# Stannah Lifts Technical Bulletin

**Issue No: M15**

## LIFT TYPE:- Midlift PX - Limit ramp.

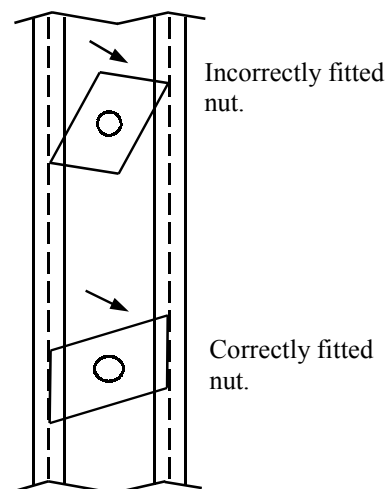
The limit ramp is fixed to a halfen channel located on the platform lift structure and is held in place by two halfen screws and nuts. It has been brought to our attention that if the nuts are incorrectly installed (see diagram below) they may exert insufficient grip to hold the ramp in position, potentially allowing the ramp to slide down the assembly thus giving a false floor level reading, whereupon it may be possible to open a landing door.

During normal service please check that the nuts have been assembled correctly, to do this the ramp will have to be removed. (For identification of component see attached photos). Note: some ramps may be made of steel others may be plastic.

The ramp should be re-assembled correctly ensuring it is in the correct position.

Please immediately report any ramps found to have incorrectly assembled nuts.
